Drift Pipe Upstream Endcap

Proposed change: "dish head" to flat flange

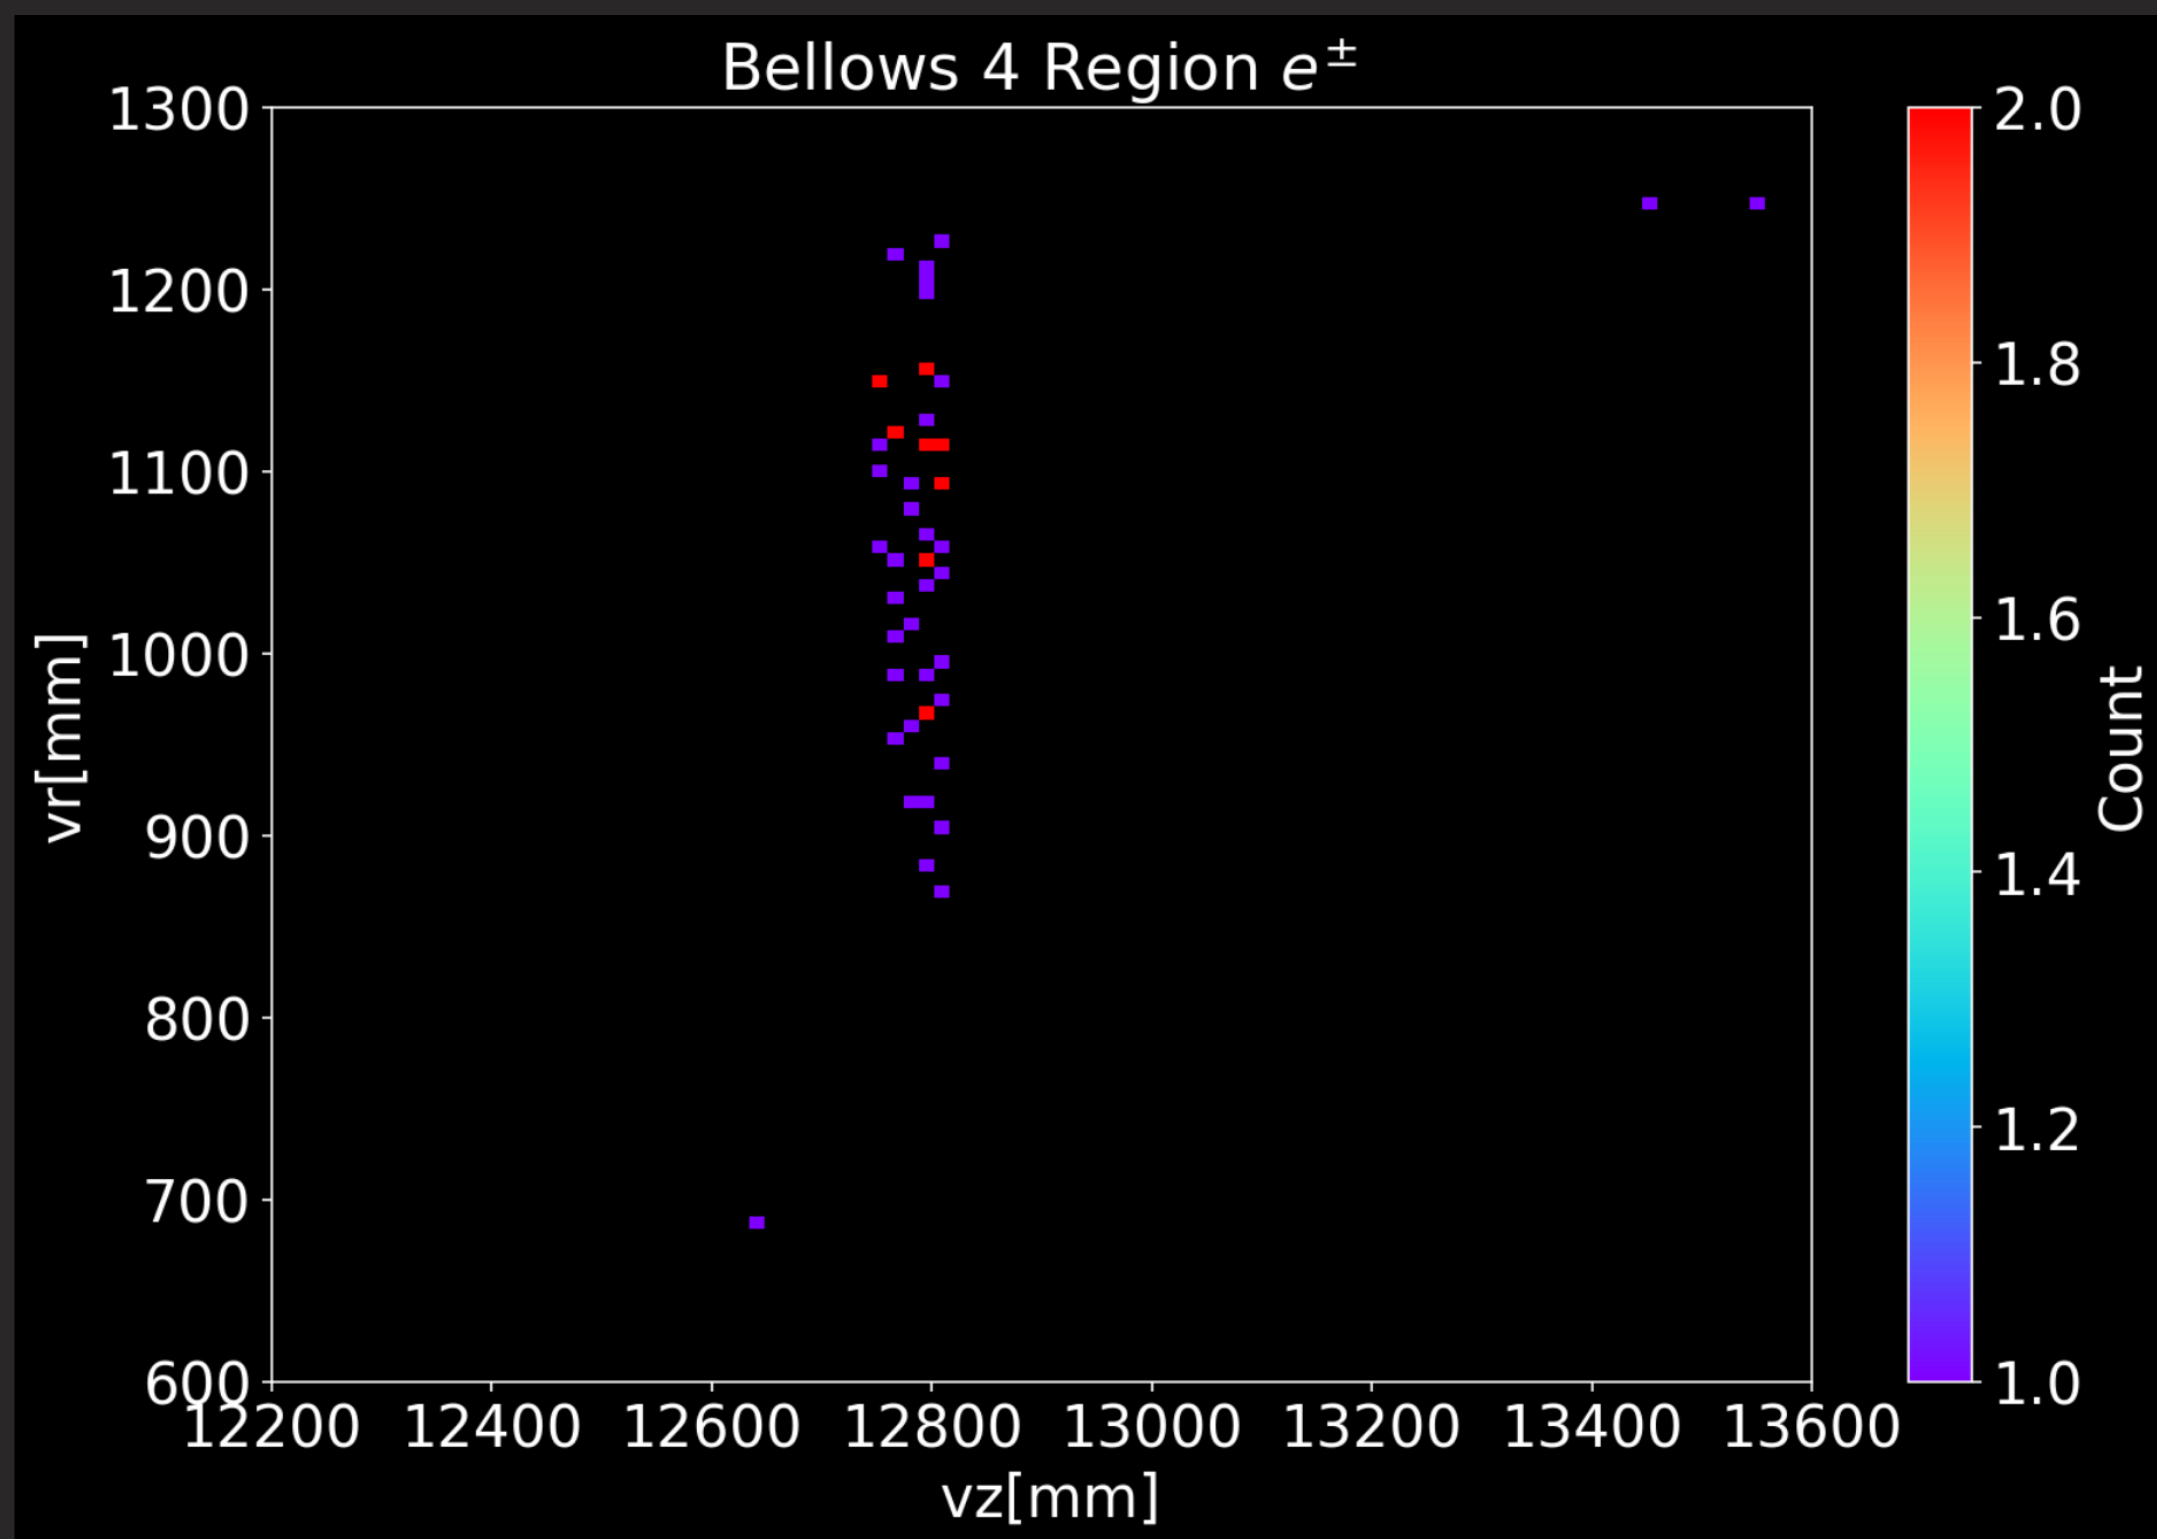
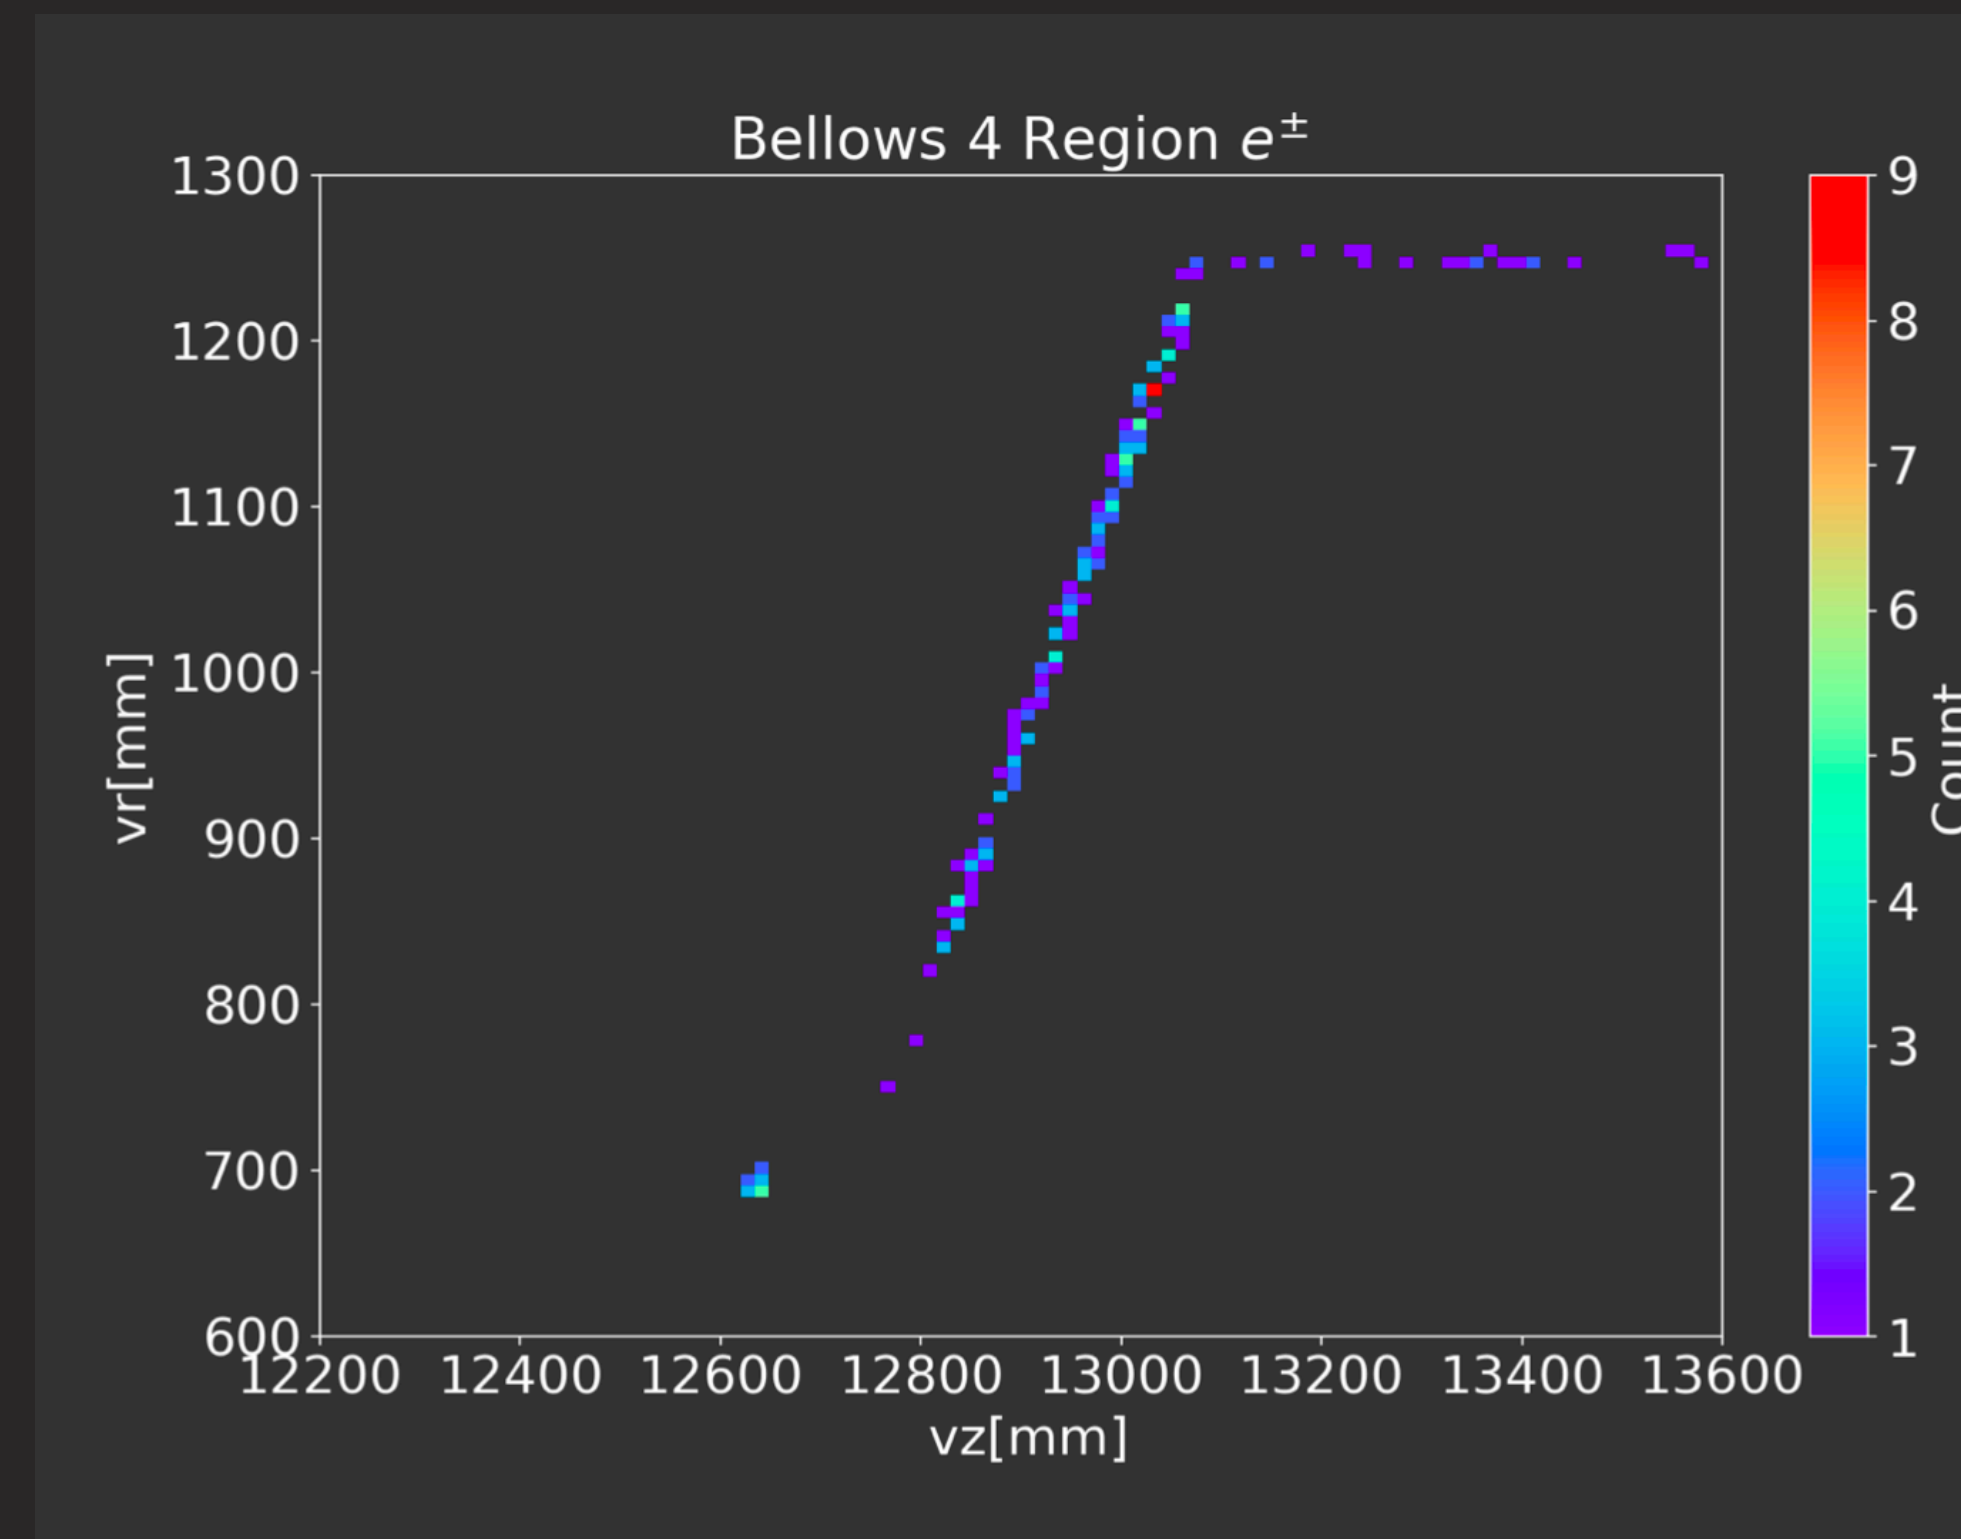
Symmetric field with new 3" configuration.
100M events

Symmetric field with old configuration.
1B events

No indication of new problem outside of Collar 1 shadow

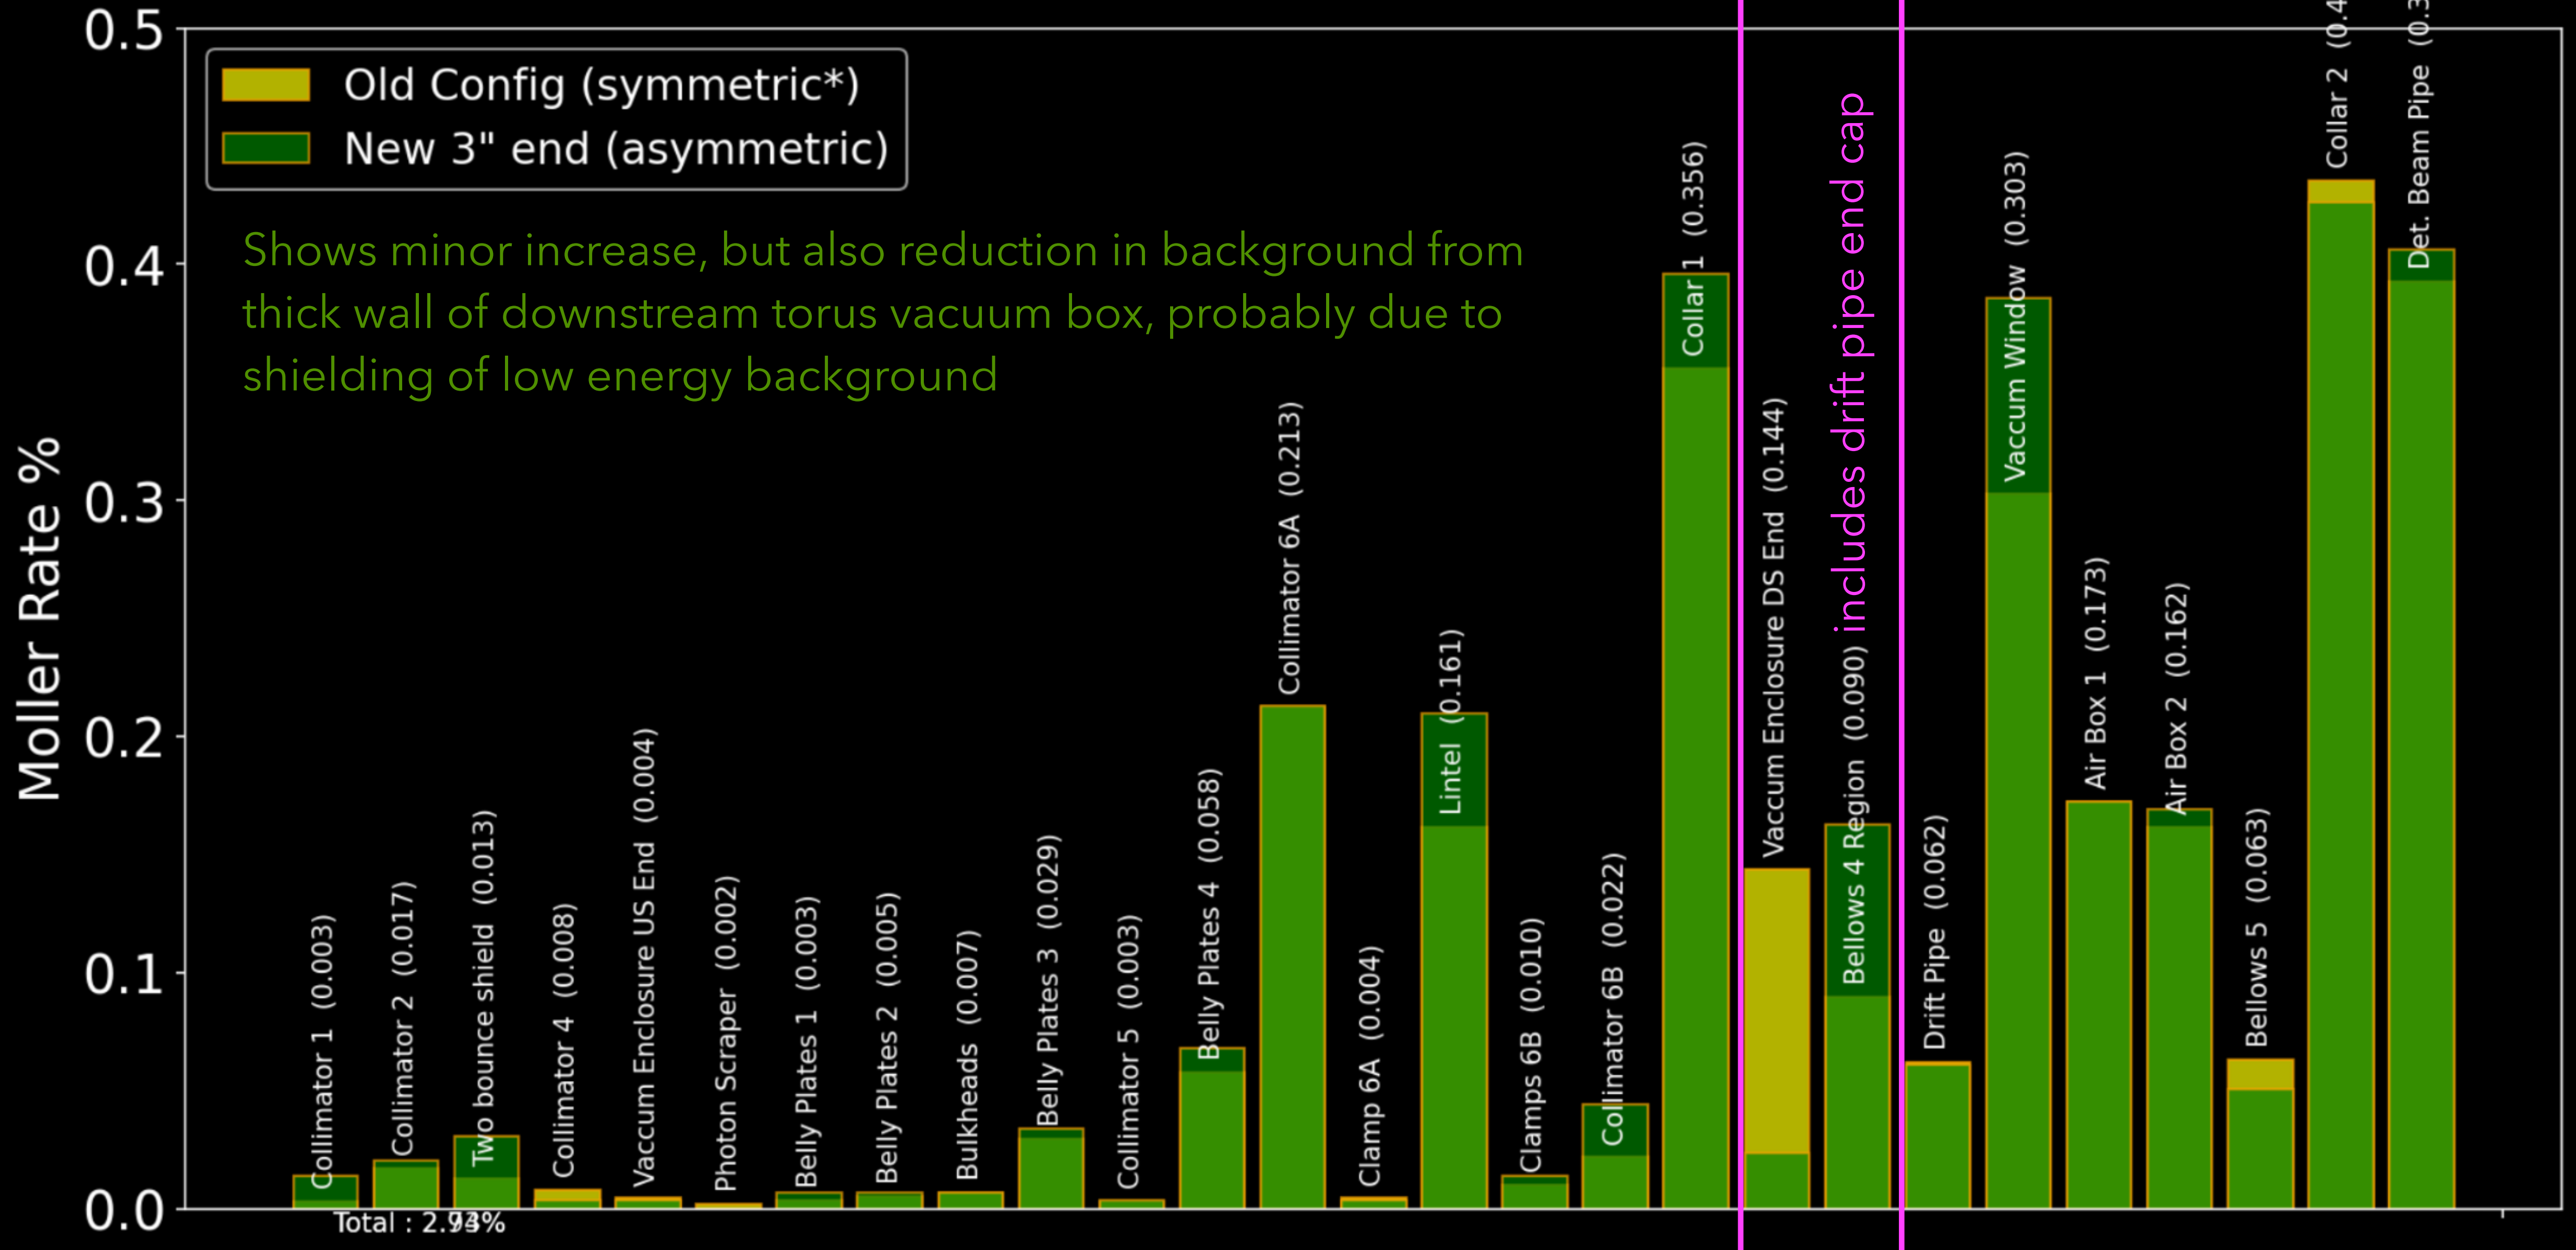
From a study of background from various edges and components (docdb:1156).

Charged "backgrounds", counting anything above Cerenkov threshold
